**Henry + Associates Project No. 21-32-052**

DSA File No. 39-50

**ADDENDUM NO. 02**  
**Modernization Lakewood Elementary School (Summer 2024)**  
Lodi Unified School District  
Lodi, California

## TEMPORARY FENCE PLAN

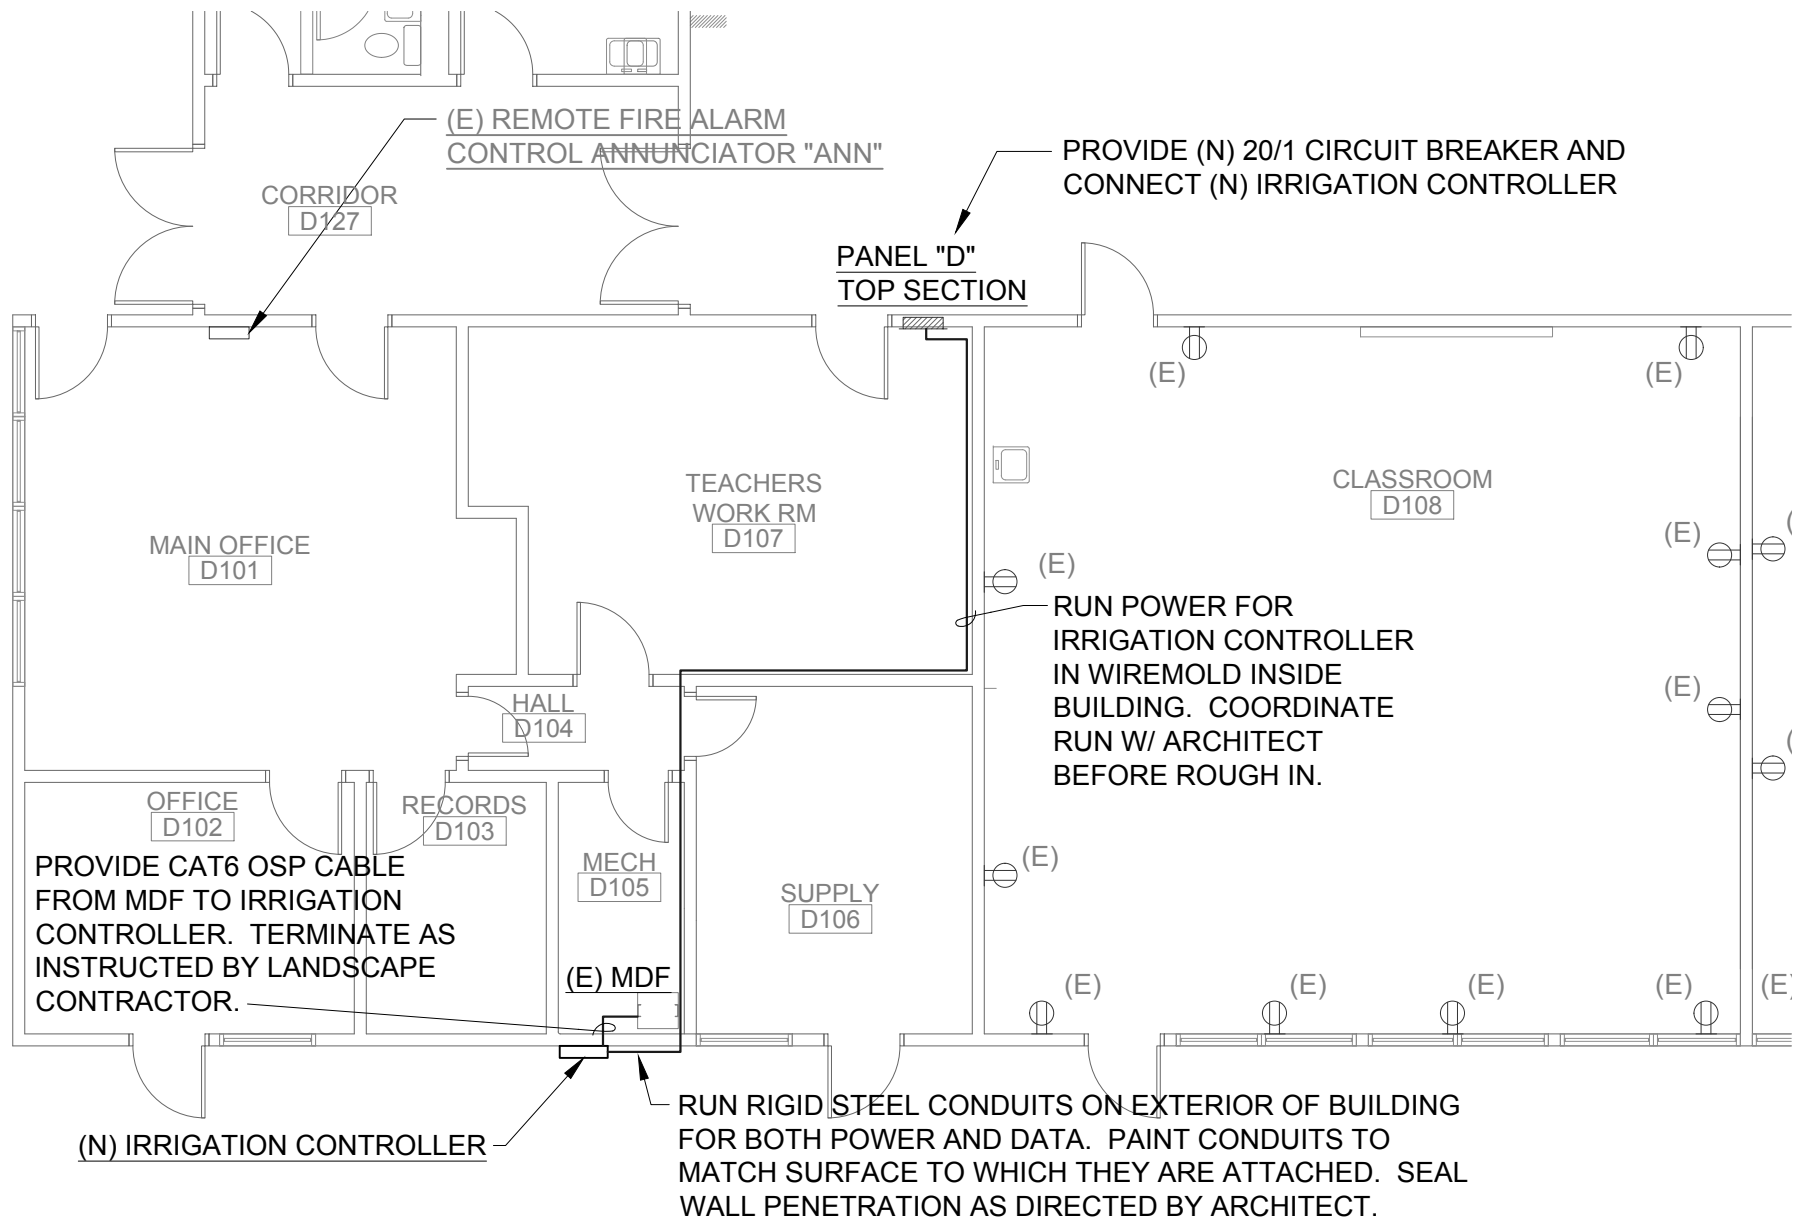
1. REVISE the Site Plan per the attached partial site plan AD2.01, TEMPORARY FENCE PLAN. The Contractor is required to provide temporary fencing as indicated on this drawing.

EXTEND TEMPORARY  
FENCING BACK TO (E) 6'  
TALL CHAIN LINK FENCE  
SECTION (APPROXIMATELY  
15') AND CONNECT

SYMBOL INDICATES APPROXIMATE  
LOCATION OF 6' TEMPORARY CHAIN  
LINK FENCING TO BE PROVIDED BY  
GENERAL CONTRACTOR AS  
REQUIRED TO SECURE ENTIRE  
SCHOOL SITE AND WORK AREAS.

NOTE:  
THE LOCATION INDICATED IS  
DIAGRAMATIC IN NATURE AND THE  
CONTRACTOR IS REQUIRED TO  
PROVIDE ALL NECESSARY  
TEMPORARY CHAIN LINK FENCING IN  
LOCATION THAT PROVIDES A  
COMPLETE SECURE BARRIER  
BETWEEN THE PUBLIC RIGHT OF WAY  
AND THE NEW WORK AND SCHOOL  
PROPERTY. LOCATION OF  
TEMPORARY FENCING MUST BE  
ACCEPTABLE TO THE CITY OF LODI  
AND THE LODI UNIFIED SCHOOL  
DISTRICT.

EXTEND TEMPORARY  
FENCING BACK TO (E) 6'  
TALL CHAIN LINK FENCE  
SECTION AND CONNECT

## SUBDRAIN TRENCH DETAIL

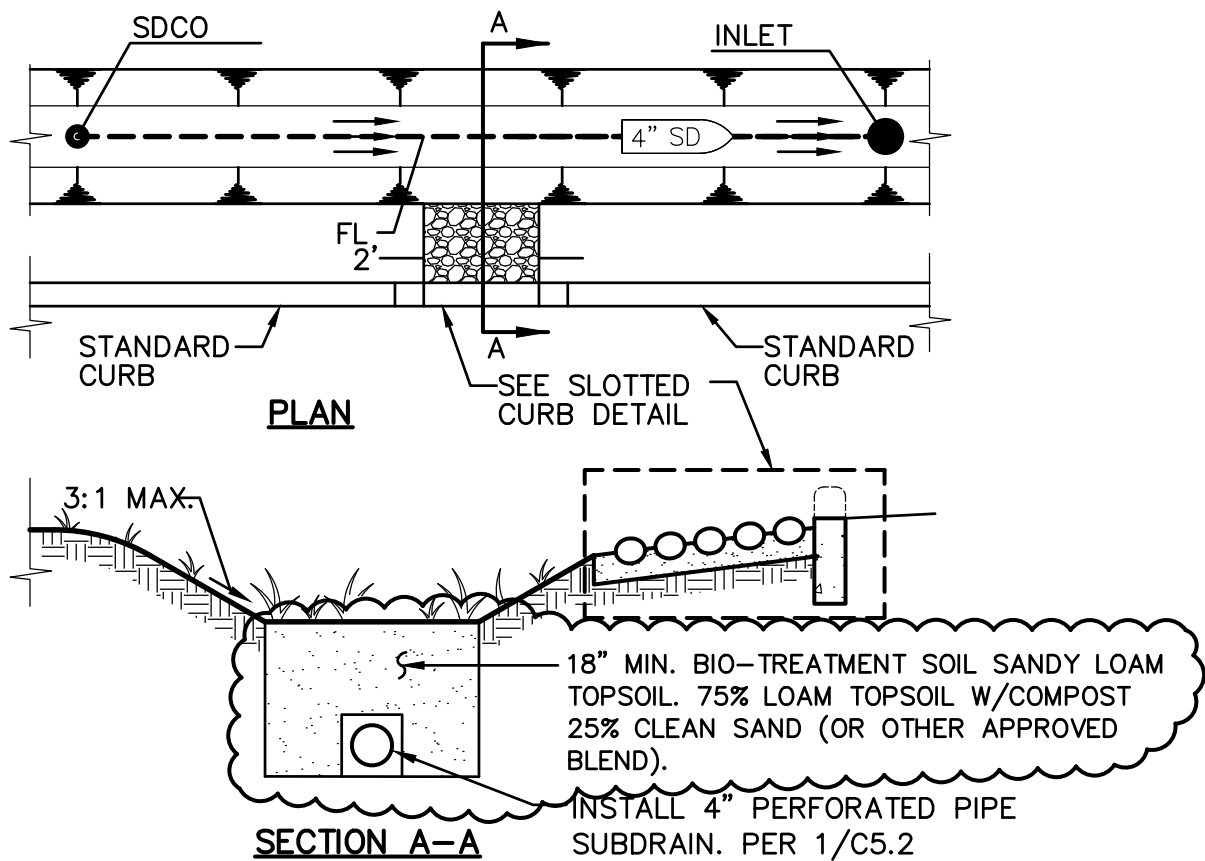
- E. SHEET C5.2:
  - 1. REPLACE detail 1/C5.2, SUBDRAIN TRENCH DETAIL with the attached drawing AD2.03.

## PARTIAL LANDSCAPE IRRIGATION PLAN

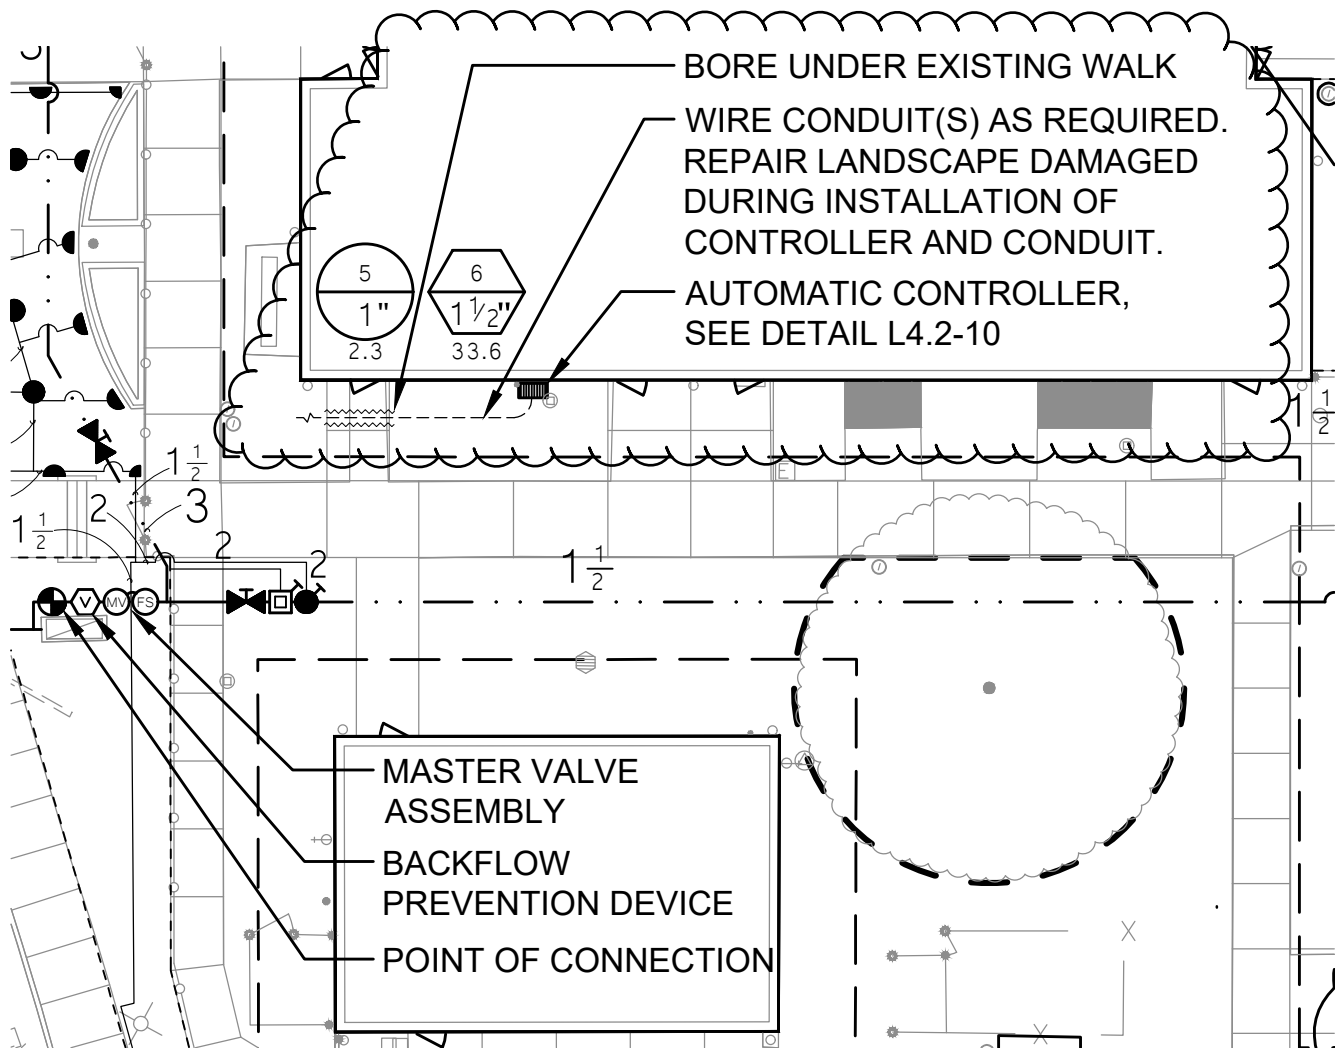
- G. SHEET L3.2:
  - 1. REVISE the Landscape Irrigation plan per the attached Partial Landscape Irrigation Plan, drawing AD2.06.
